Calaveras County Water District
Ebbetts Pass Water System
Reach 3A Pipeline Replacement Project

ADDENDUM No. 3

Date Issued: December 29, 2015

ADDENDUM 3
SAWMILL TANK CONNECTION DETAIL

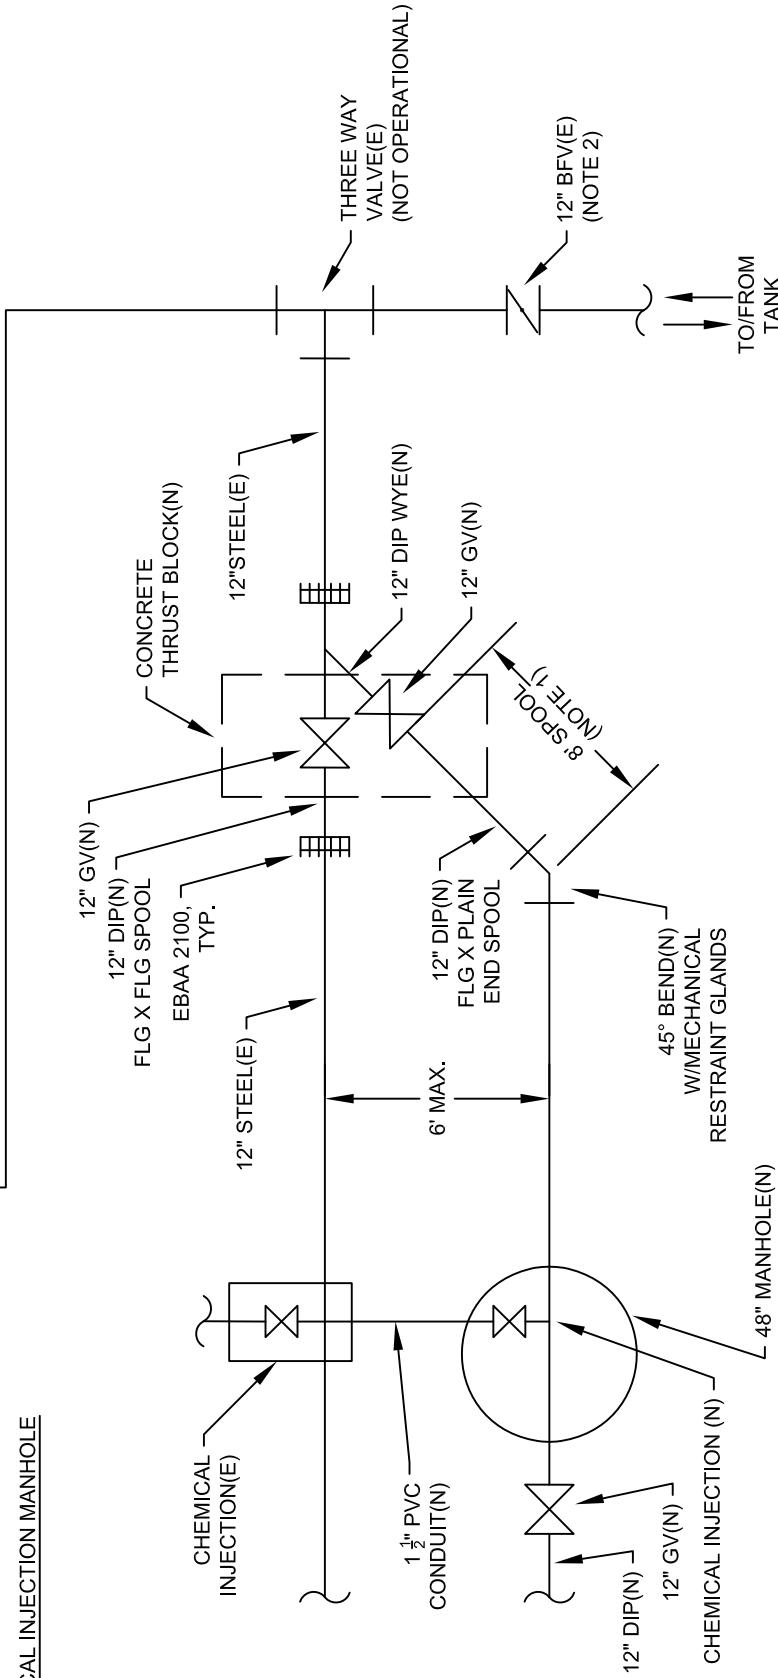
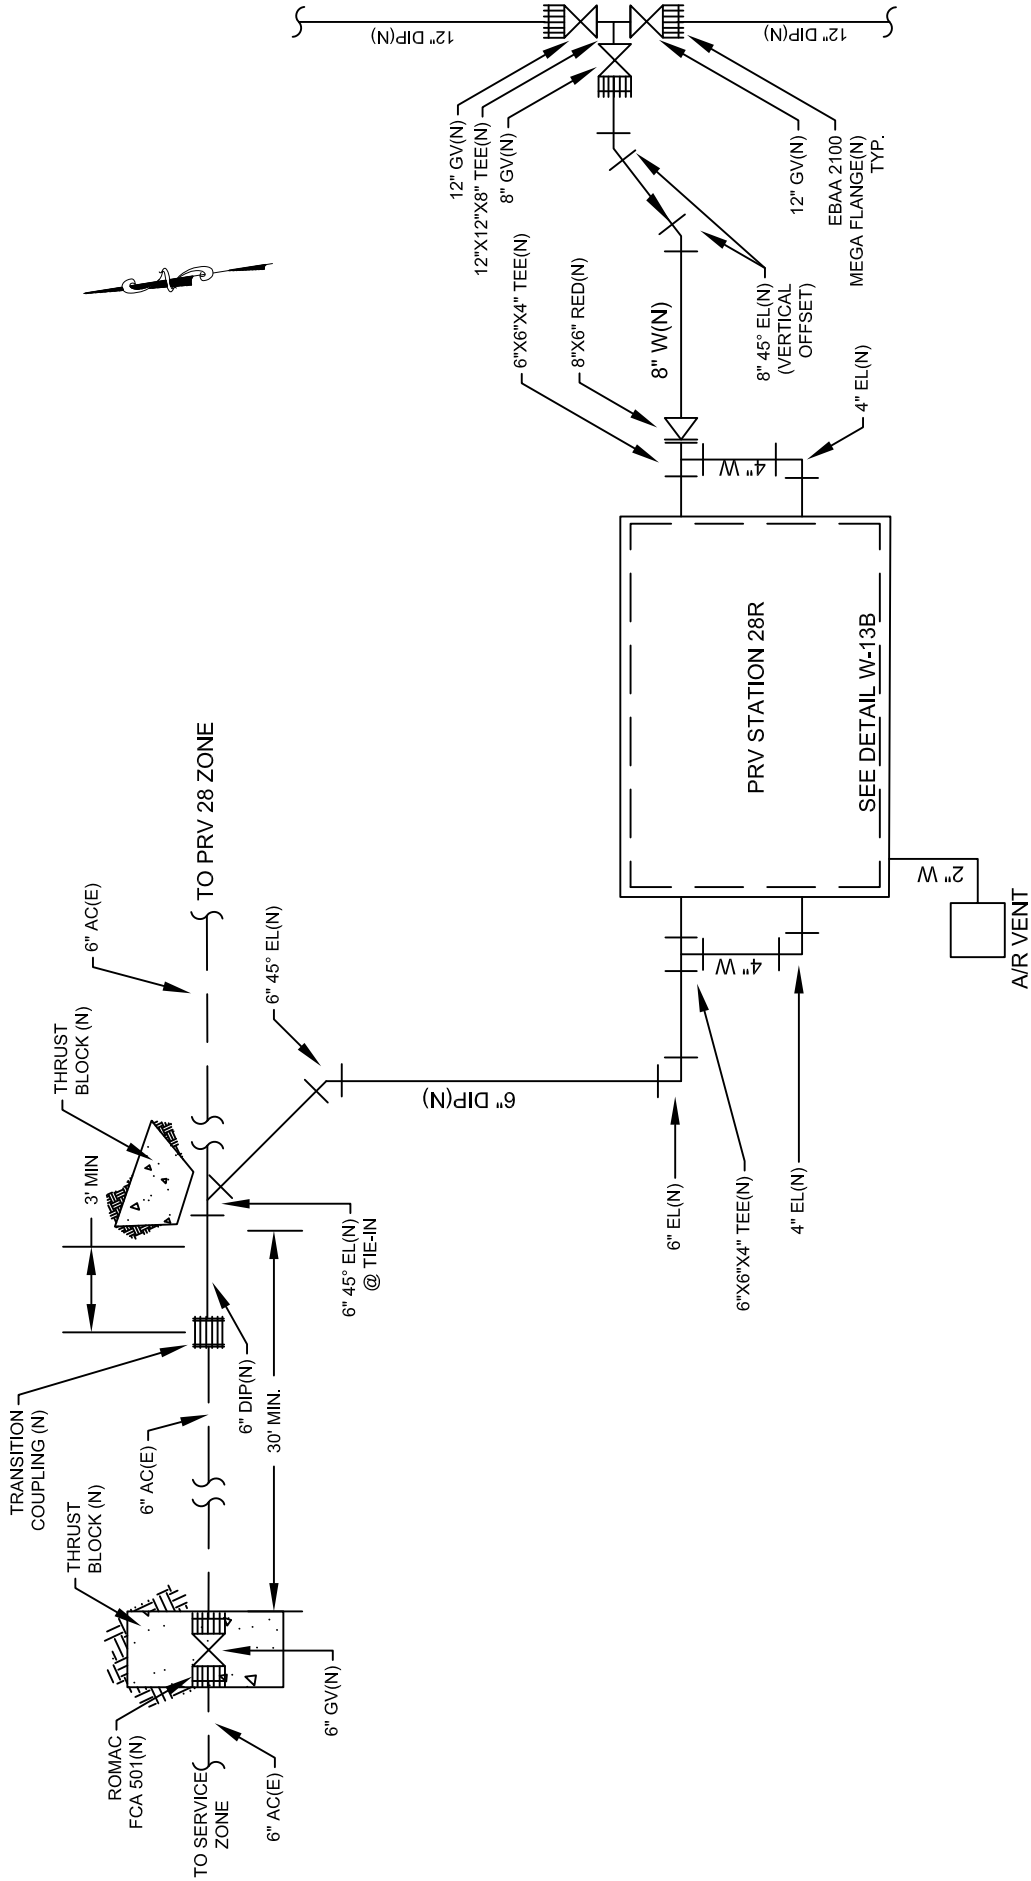
20. Drawing Y-2: The connection at Sawmill Tank site (STA 203+00 to 203+60) has been changed; delete all and substitute revised Detail 1 "Sawmill Tank Connection Detail" (attached). Chemical injection point is same per Detail 15350.

| DRAWN BY: CCWD STAFF | SCALE: NONE | CCWD STANDARD DRAWING NO. W05 (REV) |

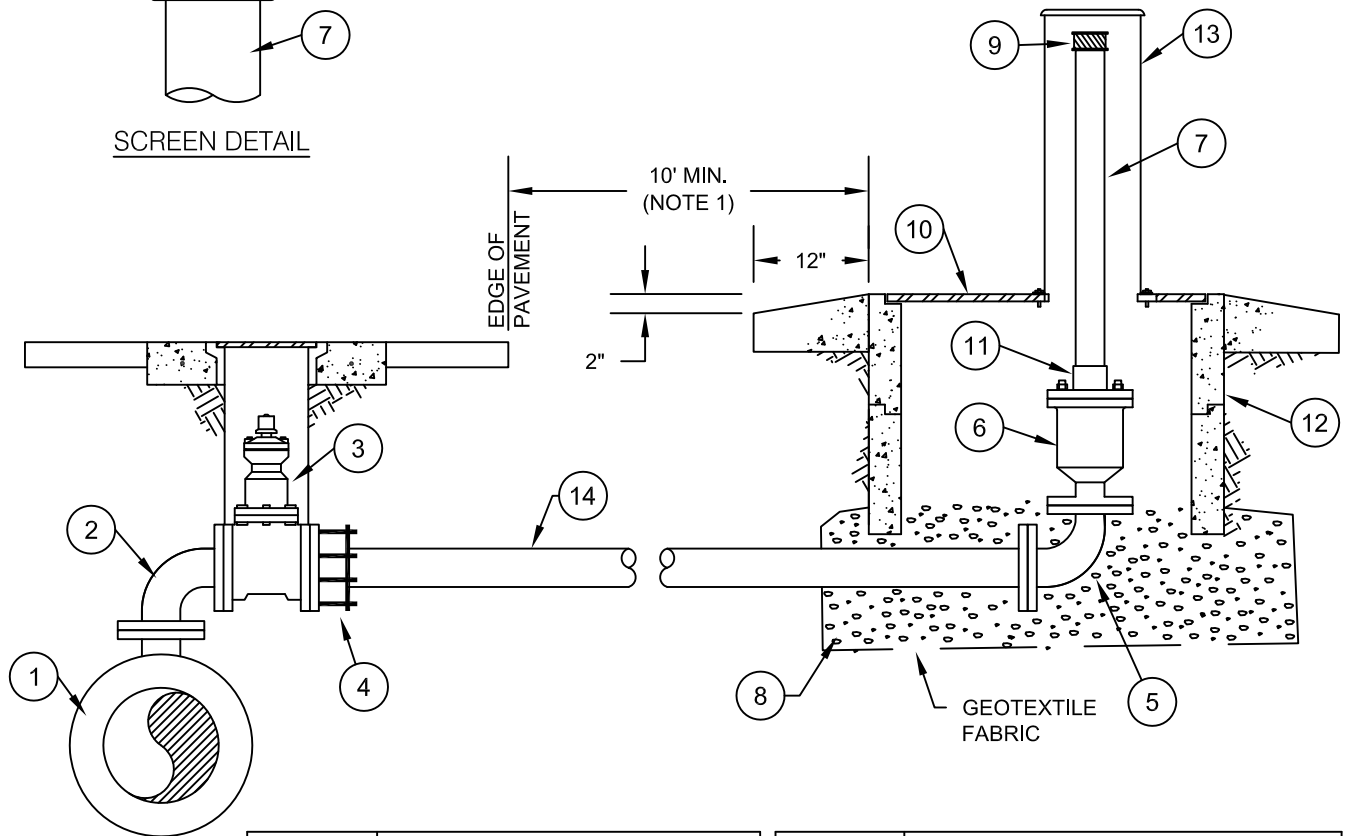
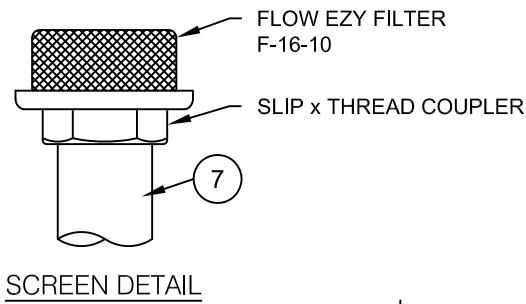
Contractor shall provide all labor, equipment and materials for 3" combination air valves per Detail W05. Air valves shall have four functions: 1) air vent upon filling, 2) vacuum vent upon draining, 3) air-release in operation, and 4) anti-surge in operation. Valve body shall be Class 300 flanged, fusion bonded epoxy coated ductile iron with 363-psi working pressure. Payment shall be for each air valve assembly furnished and installed per detail, tested, disinfected, placed in service by Contractor and accepted by District. *(Note: All air valves identified on plan and profile sheets as 2" CARV shall be changed to 3" CARV according to Addendum No.3 and revised Detail W05.)*
